This Service Information bulletin supersedes SI 34 06 15 **dated July 2015**.

### Grinding Noise from Rear Brakes

F80 (M3 Sedan)

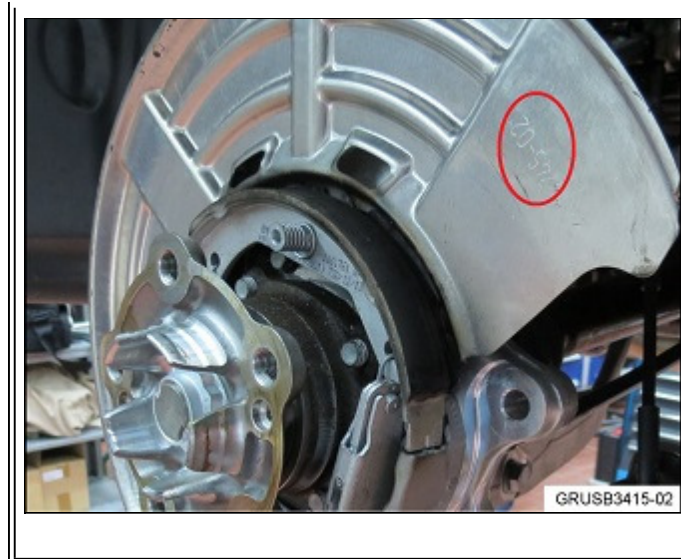
Pebbles, road grit, or other foreign materials caught between the brake protection plate and the brake disc may cause a disturbing noise in the rear axle area.

The improved protection plate can be identified by the index “03” stamped after the P/N.  
The old version has an index “02,” as shown in the photo.

If there is visible damage on the brake protection plate, replace both rear axle protection plates with the improved part per REP 34 21 280.
